In response to your applications dated December 9, 1977 and September 8, 1978, the Commission has issued the enclosed Amendment Nos. 32 and 26 to Facility Operating License Nos. DPR-42 and DPR-60 for the Prairie Island Nuclear Generating Plant Unit Nos. 1 and 2, respectively.

The amendments change the Technical Specifications that relate to the pressurizer heatup rate, the reactor vessel pressure-temperature operating limits, and the part length rods. The Table of Contents of the Technical Specifications has also been updated.

Amendment No. 32  
License No. DPR-42

Amendment No. 26  
License No. DPR-60

FIGURE TS.3.1-1

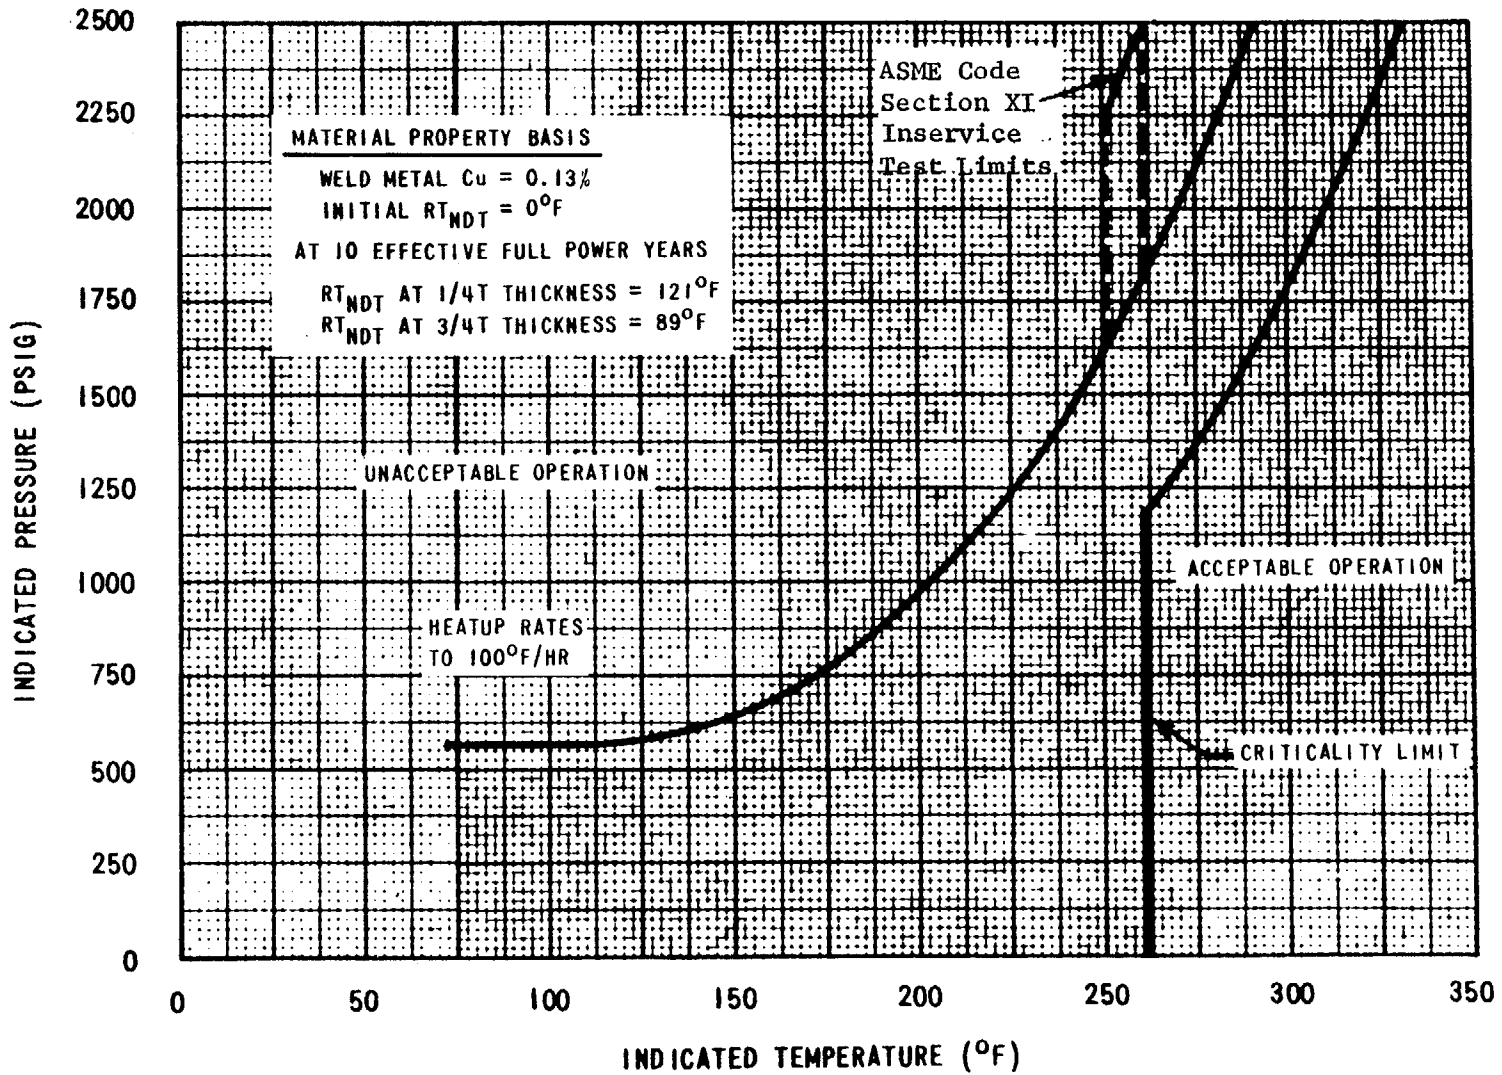
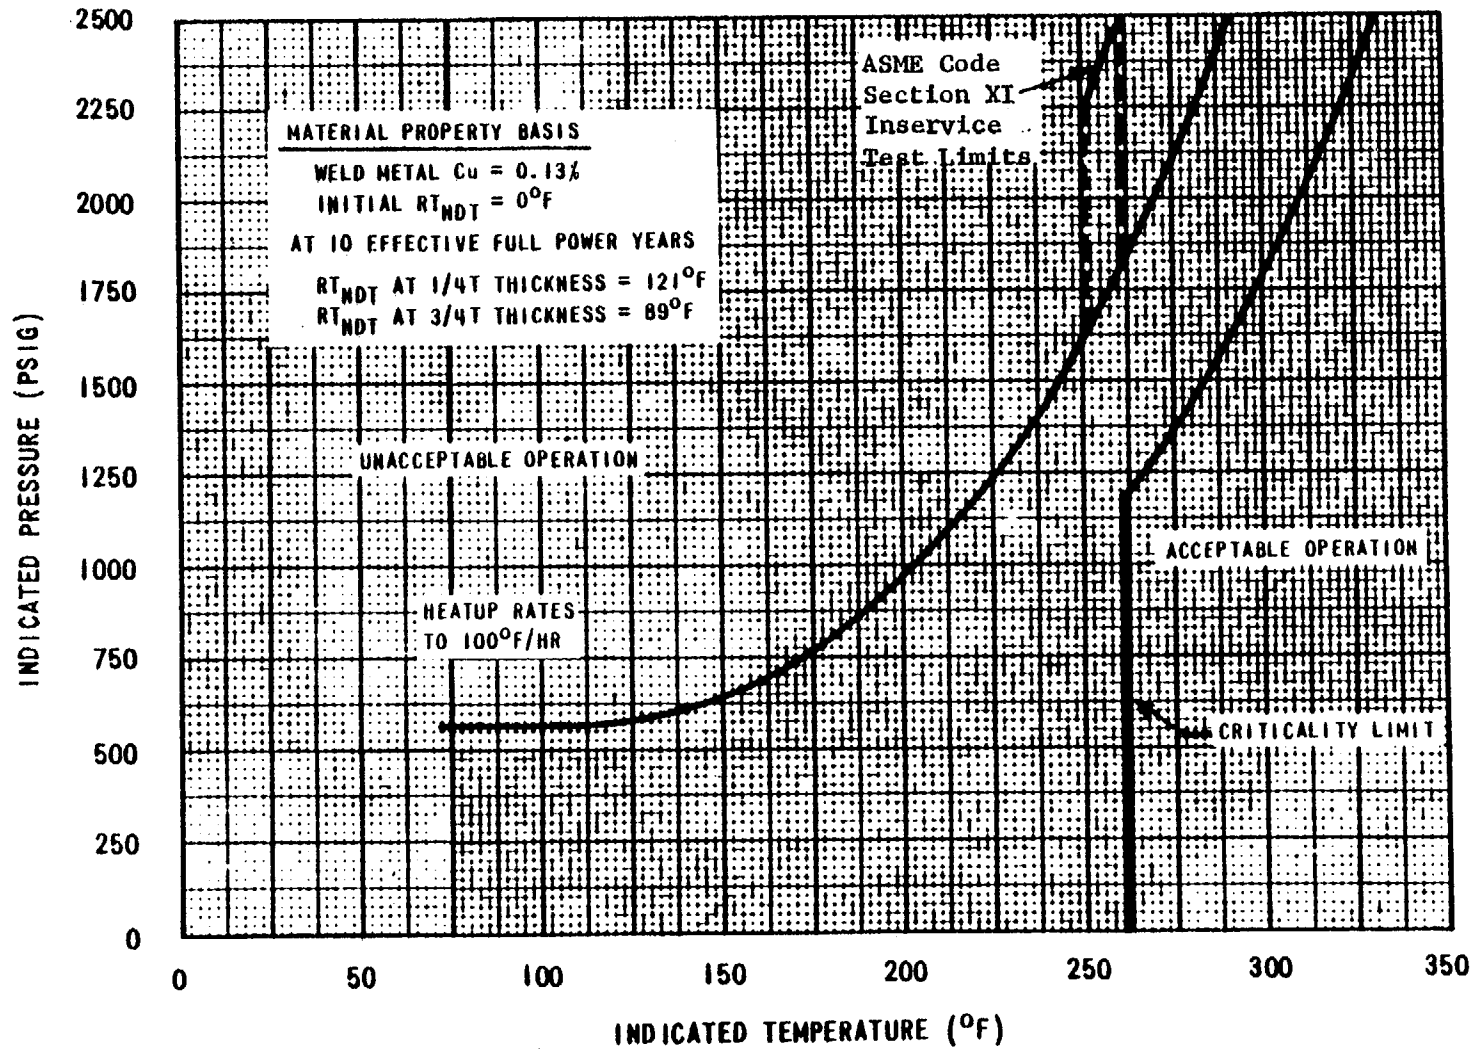
1. The Unit 1 and Unit 2 reactor coolant temperature and pressure and system heatup and cooldown rates (with the exception of the pressurizer) shall be limited in accordance with Figures TS.3.1-1 and TS.3.1-2 for the first full power service period.

In its letter dated December 9, 1977, the licensee also submitted a request to change the Technical Specifications of PINGP regarding the reactor pressure vessel pressure-temperature operating limits. The proposed operating limit curves are based on the test results obtained from material surveillance Capsule V that was removed from the Unit 1 reactor vessel.\* These revised operating limits are proposed for operation through 10 effective full power years (EFPY).

Based on the above, we conclude that the proposed operating limits are acceptable for operation through 10 EFPY.
